DOCKETED	
Docket Number:	17-SPPE-01
Project Title:	McLaren Backup Generating Facility
TN #:	225014
Document Title:	Supplemental Testimony of Robert Sarvey for Helping Hand Tools (2HT)
Description:	Exhibit 307 McLaren status conference additional testimony 10-16-18
Filer:	Robert Sarvey
Organization:	Robert Sarvey
Submitter Role:	Intervenor
Submission Date:	10/17/2018 2:14:20 PM
Docketed Date:	10/17/2018

In the Matter of
McLaren Backup Generating Facility

Docket Number 17-SPPE-01

Supplemental Testimony of Robert Sarvey for Helping Hand Tools (2HT)

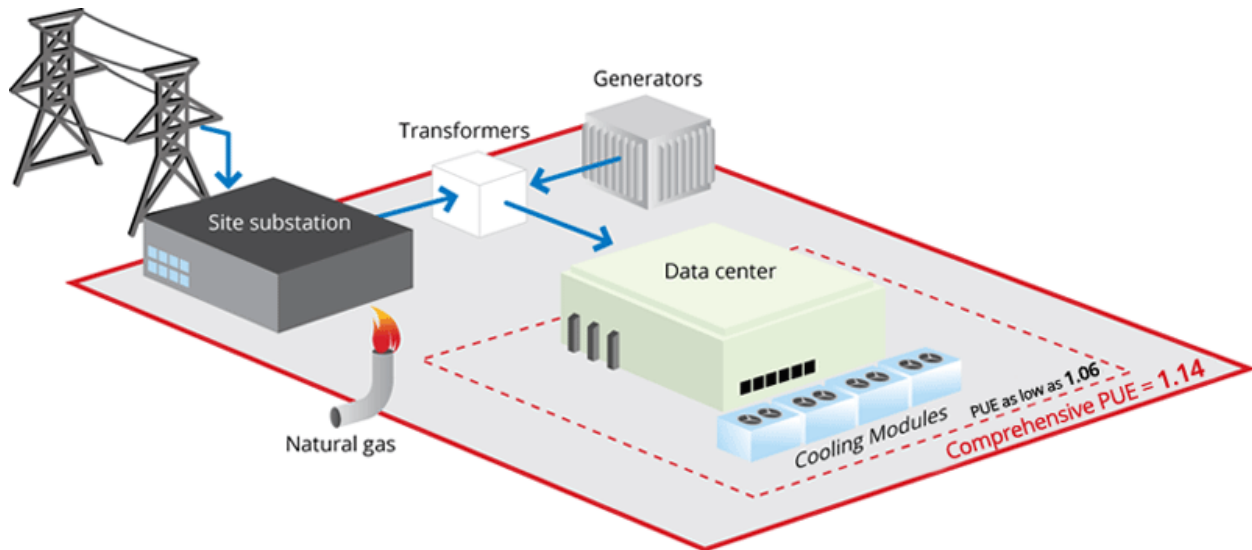
The Committee also needs to realize that PUE is not a well-defined concept and is computed differently by different data center operators. For example, PUE can include only the IT critical load and the cooling, and reflect a lower PUE but if the projects total power consumption including site substation, generators, transformers, and electrical losses are included the projects PUE can be much higher.¹⁵ (See example below)
